TOPIC STATEMENT OF COMMON GROUND – LIVING CONDITIONS RfR5

APPEAL REFERENCE APP/X3540/W/19/3242636

APPELLANT Capital Community Developments Ltd

Land North Of Gardenia Close And Garden Square Rendlesham Suffolk.

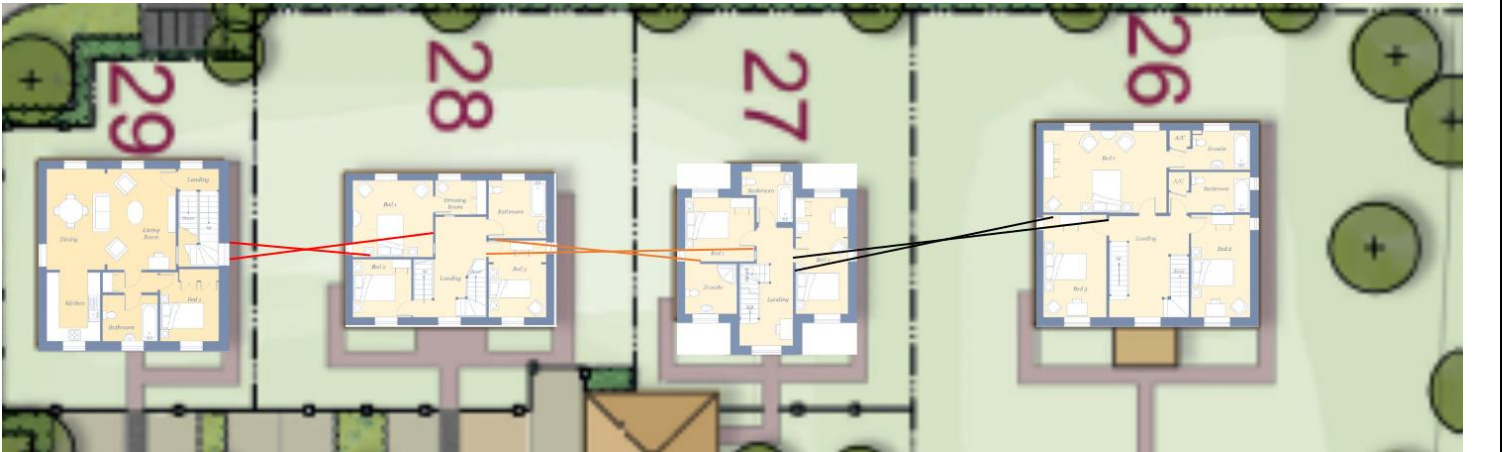
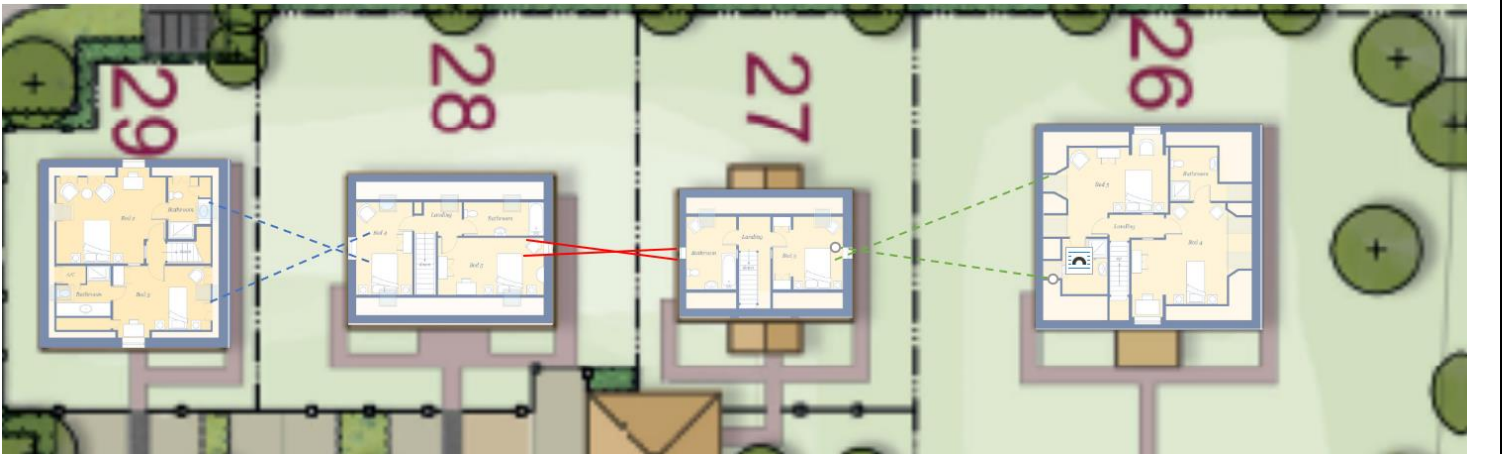
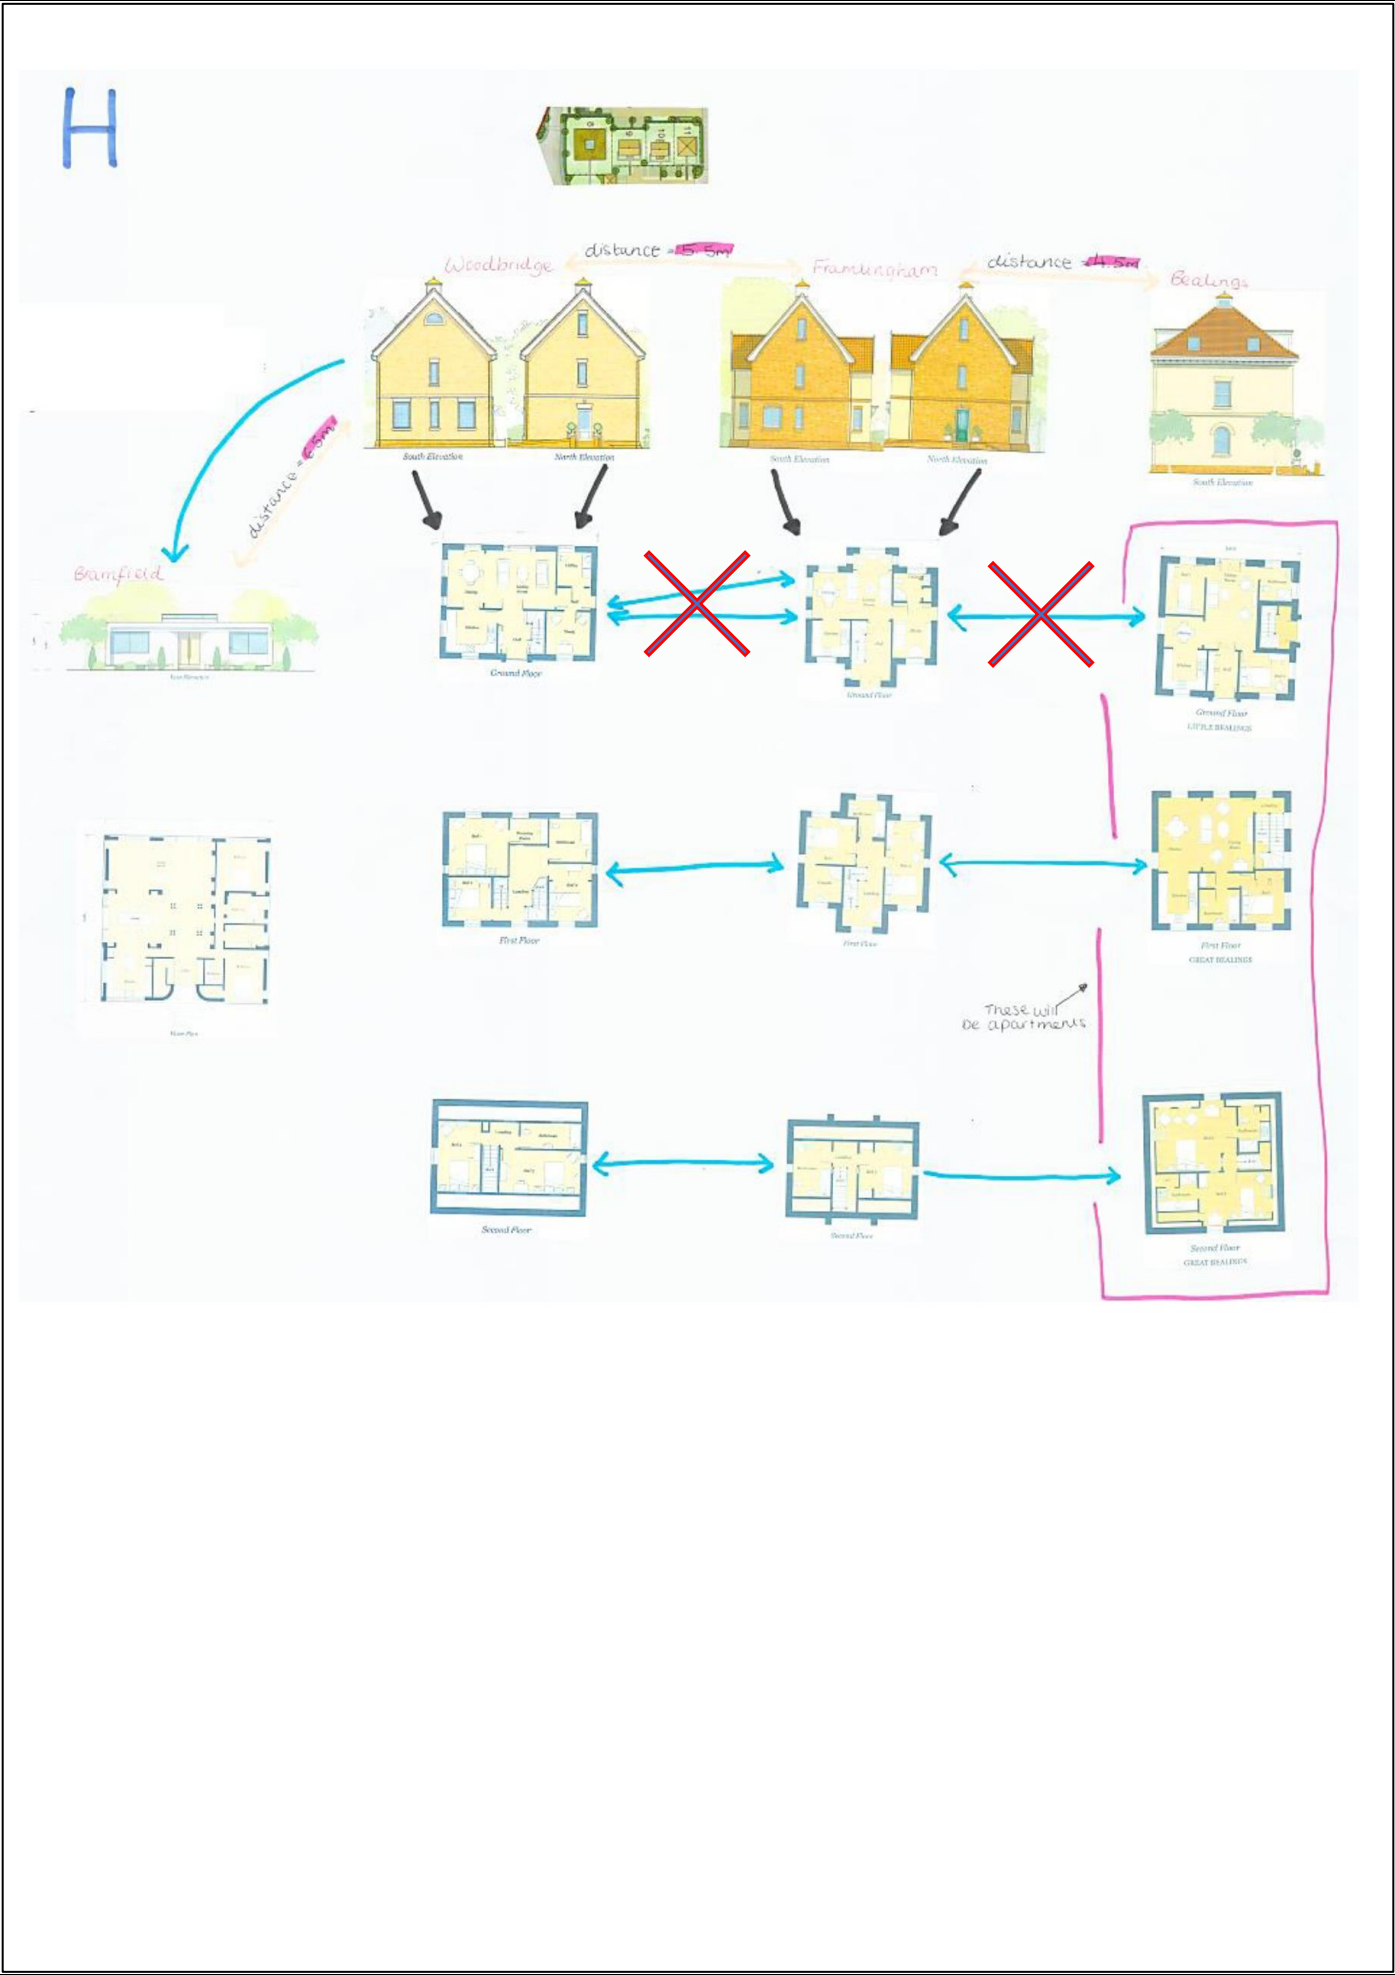
- Of the 3x potential examples of first floor level overlooking which the LPA have alluded to, we make the following comments:
- The 1x instance between plot 29 (Bealings) and plot 28 (Woodbridge) is between a window over a stairwell to a narrow bedroom window (red lines below). The bedroom window in the Woodbridge could be obscure glazed if need be.
 - The 1x instance between plot 28 (Woodbridge) and plot 27 (Framlingham) is between two narrow slot windows (orange lines below) which, not being principle windows, could easily be obscure glazed.
 - The 1x instance between plot 27 (Framlingham) and plot 26 (Easton) is over a distance of some 9 metres (black lines below) and is between two narrow slot windows and only offer views of the bedroom wall of the south elevation first floor bedroom to plot 26. Either window could be obscure glazed if the LPA or Inspector thought it justified.

- Of the 3x potential examples of second floor overlooking which the LPA point to in their ‘Area G’, we make the following comments:
- The relationship between plot 29 (Bealings) and plot 28 (Woodbridge) is unlikely to have an adverse amenity impact because the likelihood of a person standing in the second floor bedroom of the Woodbridge and being able to look over the lip of the above-head height arched window in the southern elevation of the Woodbridge is very low (blue lines below).

- The 1x instance of potential overlooking between plot 28 (Woodbridge) and plot 27 (Framlingham) is non-existent because the LPA should have assumed the bathroom window in the Framlingham would be obscure glazed.

- The 1x instance of potential overlooking between plot 27 (Framlingham) and plot 26 (Easton) is over a distance of some 9 metres (green dashed lines below) and is to three rooflights; one of which is to a bathroom and should have been assumed by the LPA to be obscure glazed. The other two rooflights are at an obscure angle not well represented in the LPAs evidence’ they too could be obscure glazed IF the LPA or Inspector felt it justified.

None of the 13x examples provided in the LPAs evidence are justified or cannot be easily dealt with by simple planning controls.

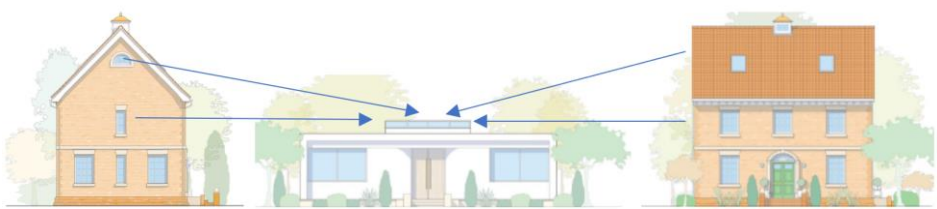
In relation to the 1x instance of potential overlooking from plot 9 to plot 8 we have the following comments:

- The potential view from plot 9 (Woodbridge) at first floor level is non-existent because it is at the same level as the skylight.
- The potential view from plot 9 (Woodbridge) at second floor level is via a half-moon window with a 1.7m cill height and therefore only offers a view over the top of the bungalow at plot 8 from a very limited area within the southern elevation bedroom of plot 9. In addition, the potential view to the skylight of the Bramfield is at a low angle of incidence giving limited visibility through the skylight which may be effectively blocked by glare on the glass at that angle. In any event, obscure glazing the second floor half-moon window in the Woodbridge would completely rule out any issue in this relationship and the LPA should have investigated this during the planning application. We have shown this below by placing the Woodbridge arbitrarily either side of the Bramfield to illustrate the point:

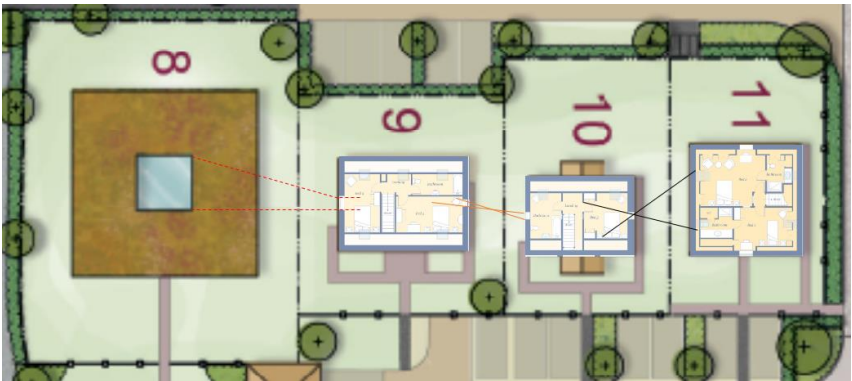
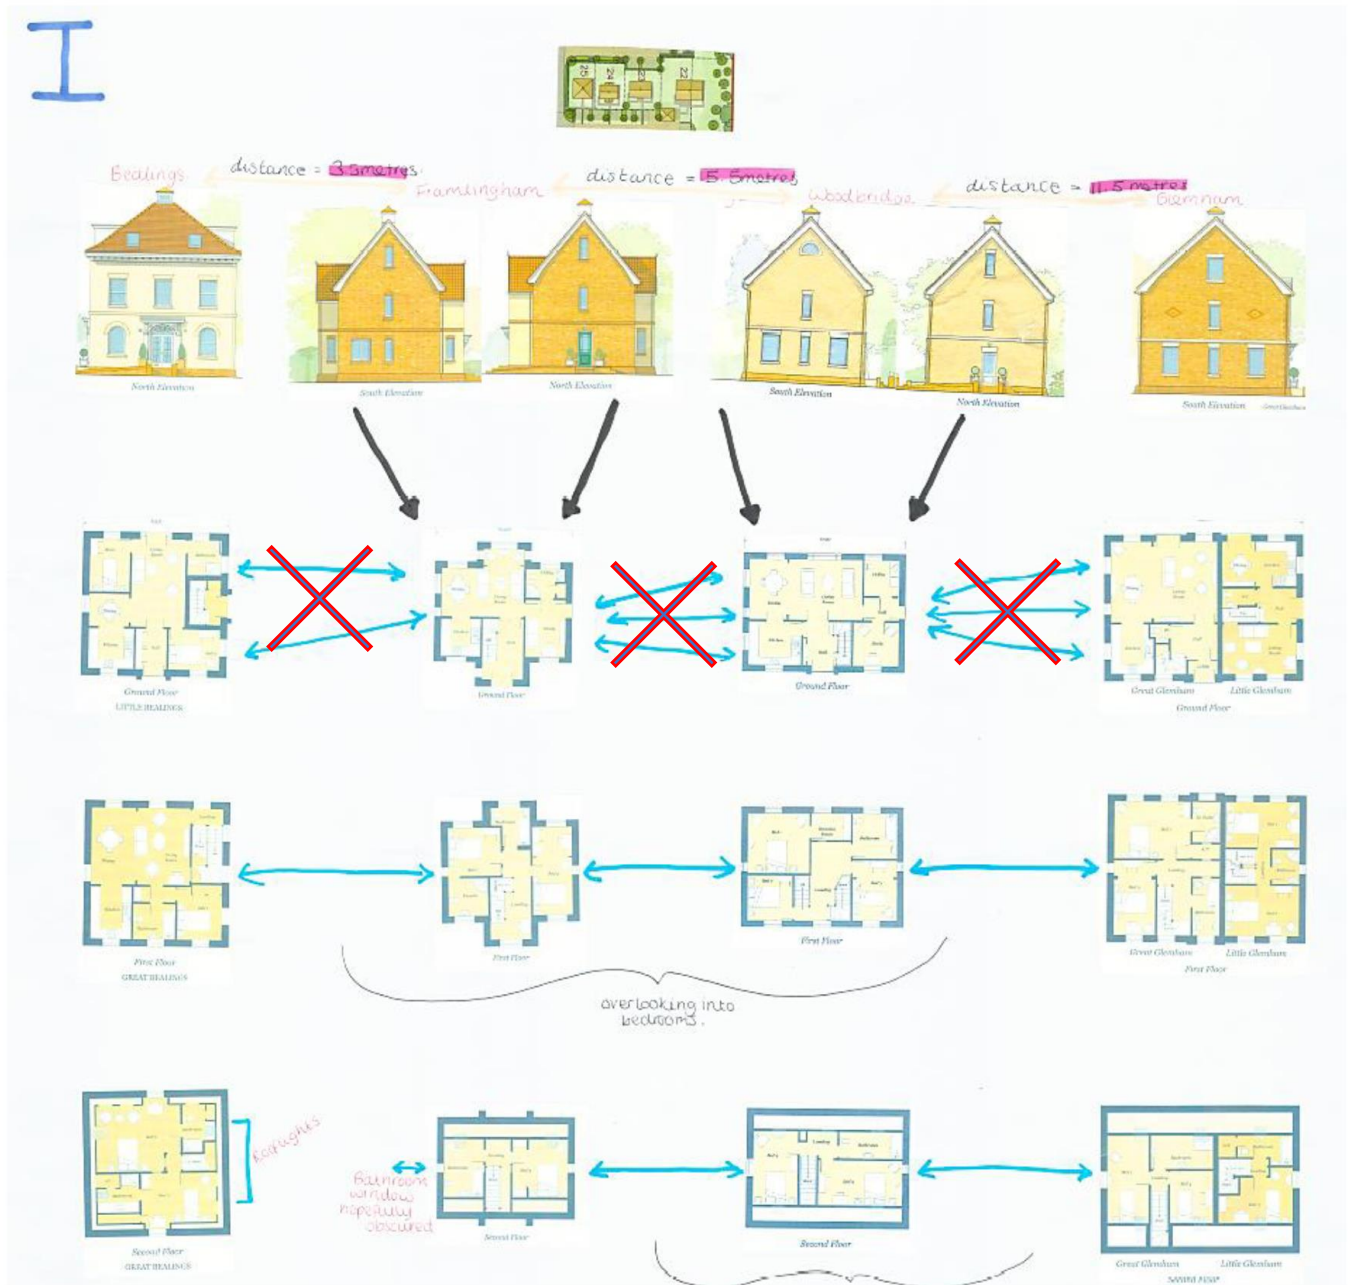
In relation to the 2x instances of potential overlooking at first floor we make the following comments:

In relation to the 2x instances of potential overlooking at second floor we make the following comments:

- The views between plot 9 (Woodbridge) and plot 10 (Framlingham) are only possible through narrow slot windows from very small areas of the bedrooms. If necessary, this could have been overcome through the provision of obscure glazing to windows and the LPA should have considered this.
- The views between plot 10 (Framlingham) and plot 11 (Bealings) are at a more obscure angle than the LPA evidence shows. The window in the Bealings is a narrow slot window that could be obscure glazed if the LPA considered it necessary.

- The view from plot 9 (Woodbridge) to plot 10 (Framlingham) is to a bathroom in the Framlingham and as such the LPA should have assumed the window would be obscure glazed.
- The view from plot 10 (Framlingham) to plot 11 (Bealings) is from a narrow slot window at an obscure angle to rooflights in the Bealings; one of which is to a bathroom and as such should have been assumed to be obscure glazed. The remaining rooflight is related at such an extreme angle that direct views are potentially impossible.

None of the 8x examples provided in the LPAs evidence are justified or cannot be easily dealt with by simple planning controls

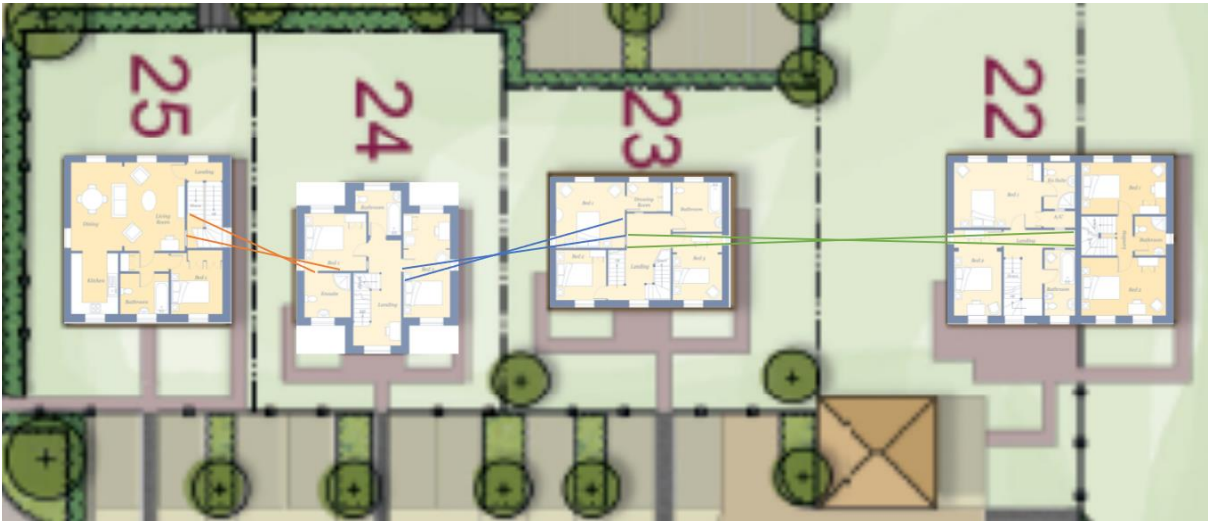
In relation to the 3x instances of potential overlooking at first floor we make the following comments:

- The view from plot 25 (Bealings) and plot 24 (Framlingham) is at an extreme angle and through a narrow slot window in the first floor bedroom of plot 24. If the LPA had considered it necessary, the window could have been obscure glazed.
- The view from plot 24 (Framlingham) to plot 23 (Woodbridge) is between two narrow slot windows which are offset from each other at an angle. If the LPA thought it justified it could have required either of the windows to be obscure glazed.
- The view from plot 23 (Woodbridge) to plot 22 (Glemham) is 11.5m and between narrow slot windows. The affected rooms are landings and therefore unlikely to be adversely affected in terms of amenity.

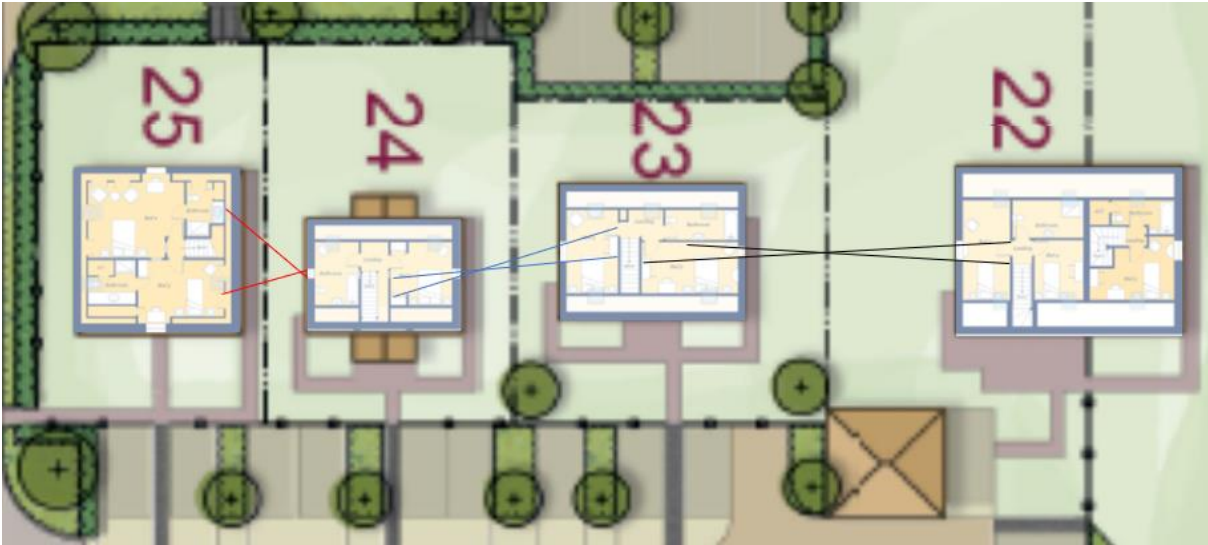
In relation to the 3x instances of potential overlooking at second floor we make the following comments:

- The view between plot 25 (Bealings) and plot 24 (Framlingham) is to a bathroom window in the Framlingham and as such the LPA should have assumed the window would be obscure glazed.
- The view between plot 24 (Framlingham) and plot 23 (Woodbridge) is between a narrow slot window and is at an obscure angle. The first floor bedroom northern elevation window of the Framlingham could have been obscure glazed if the LPA thought it necessary.
- The view from plot 23 (Woodbridge) to plot 22 (Glemham) is 11.5m and between a narrow slot window and a half-moon window with a 1.7m cill height and therefore unlikely to be adversely affected in terms of amenity. If the LPA had justifiable concerns either window could have been obscure glazed.

None of the 8x examples provided in the LPAs evidence are justified or cannot be easily dealt with by simple planning controls

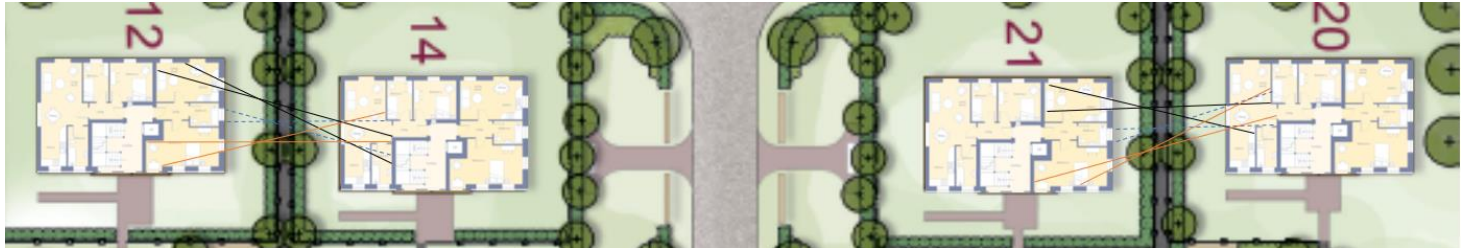
In relation to the 6x instances of potential overlooking at first floor we make the following comments:

In relation to the 2x instances of potential overlooking at second floor we make the following comments:

- The blue dashed lines represent views to bathroom windows and as such the LPA should have assumed these would be obscure glazed.
- The black and orange lines represent views over 10m and to non-principle windows which could have been obscure glazed if the LPA thought it was justified over a distance of 10m.

- The views are between rooflights at a distance of 10m. The rooflights could have been controlled to be non-opening or obscure glazed if the LPA had considered the matter and considered it justified to do so.

None of the 14x examples provided in the LPAs evidence are justified or cannot be easily dealt with by simple planning controls
